KHA RESPONSE, TYP.  
05/27/21

# PARKER AND PINE FILING NO. 2 LOTS 1-3 MULTI-FAMILY SITE PLAN

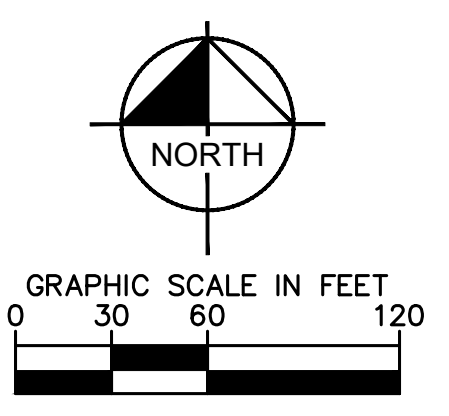
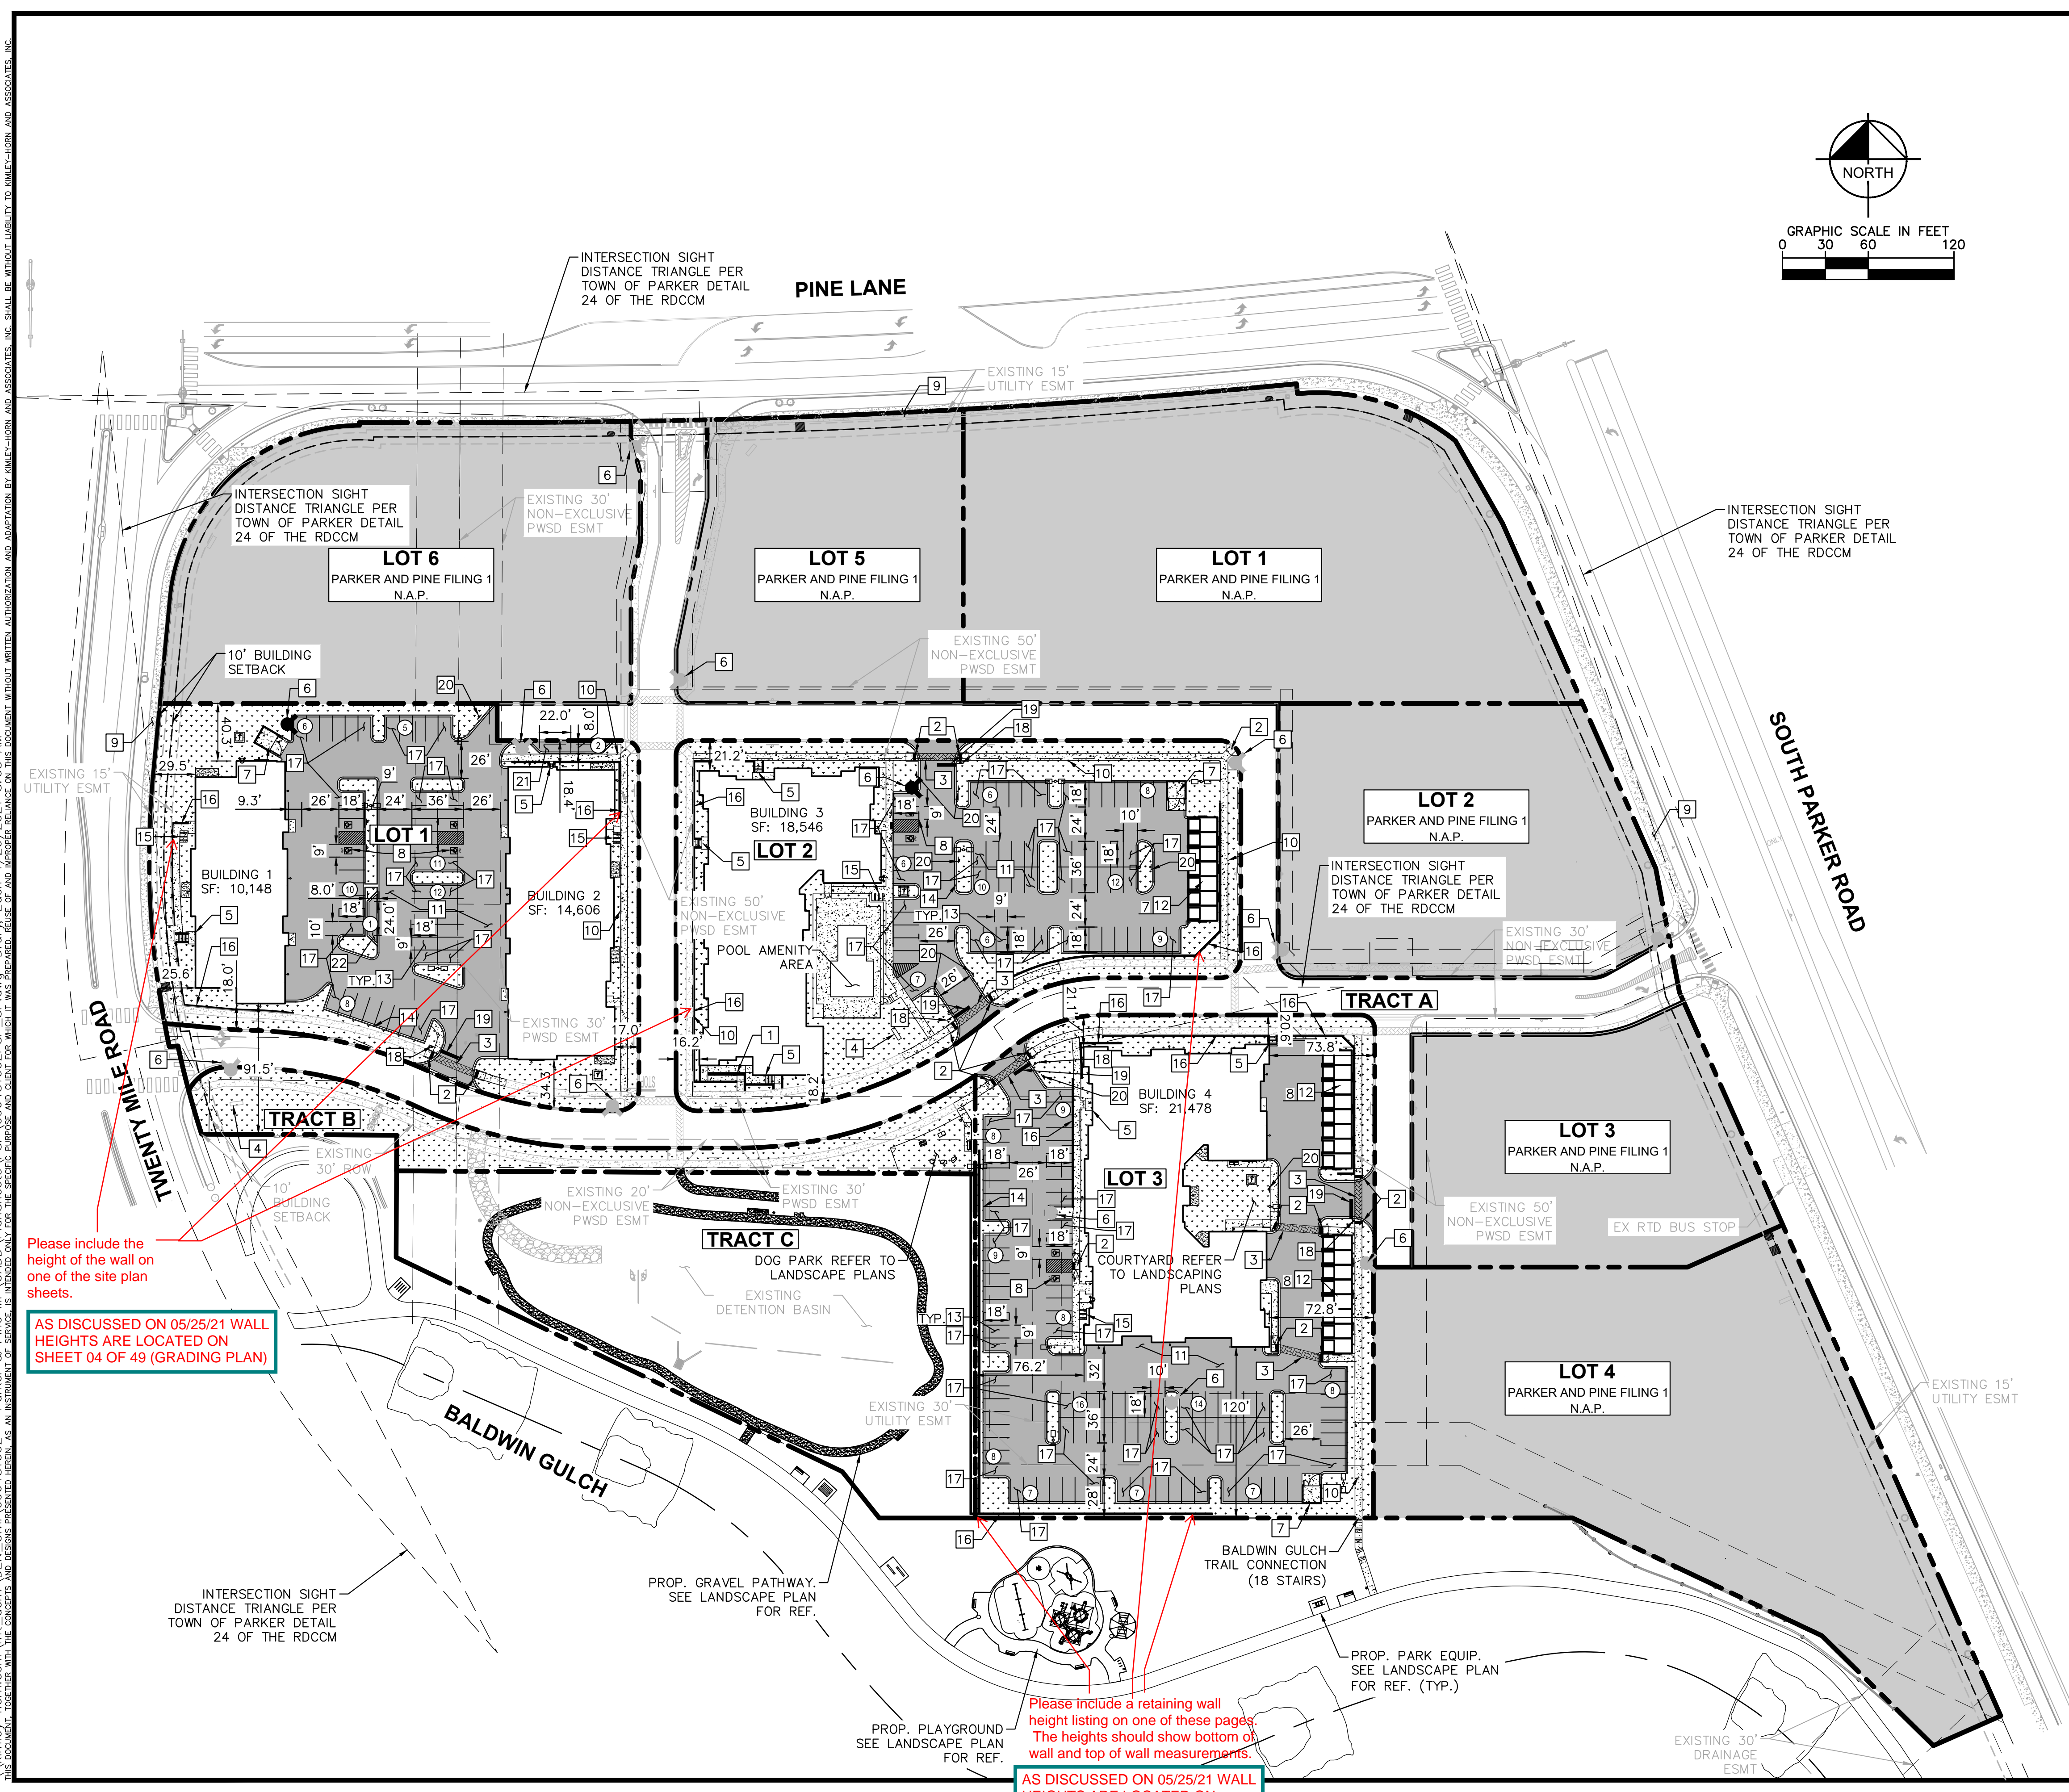
**TOWN OF PARKER PLAN REVIEW:**  
20120 E. MAIN STREET  
PARKER, CO 80138  
TEL: (303) 805-3174  
CONTACT: BRYCE MATTHEWS
